# Service Bulletin

| Category<br>S | Applicable Model/s<br>1995-96 Millenia | Subject<br>GLOVE BOX LID DOES NOT FIT FLUSH<br>WITH DASH BOARD SURFACE | Bulletin No. 041/96 |

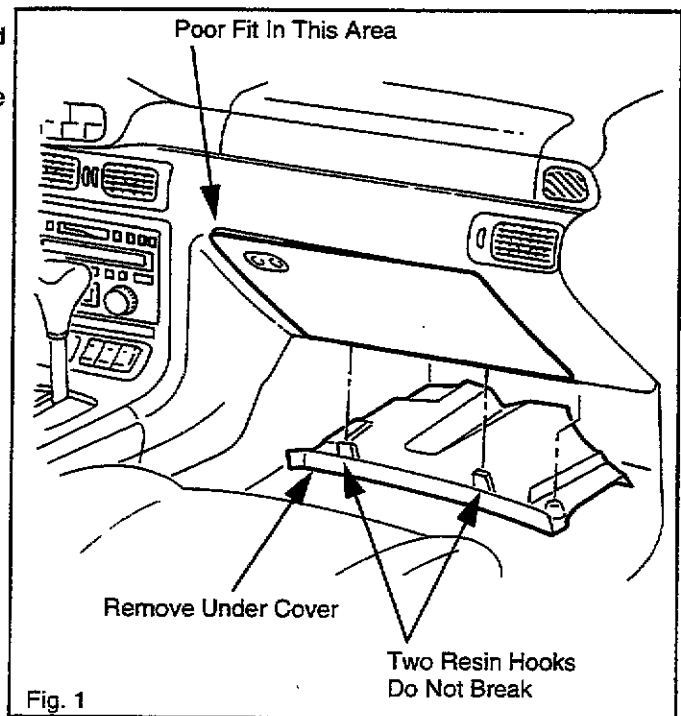
The glove box lid may not fit flush (left side lifting) with the dash board when the lid is closed. This condition is caused by the glove box compartment cushion rubber. The elasticity of the cushion rubber pushes the glove box compartment outward.

The cushion rubber has been changed and the fit of the crash pad inside the dash is improved to prevent this concern.

**NOTE:** When removing the under cover, take precautions not to break the two (2) resin hooks at the rear of the under cover. Refer to Fig. 1.

1. Remove the under cover right side screw and under cover.

2. Remove the right side (door side) glove box compartment hinge screw.
3. Insert two (2) washers between the hinge and the bracket.
  - Retighten screws.
4. Close the glove box lid and verify proper fit.
  - If the problem still exists, adjust the number of washers until proper fit is achieved.
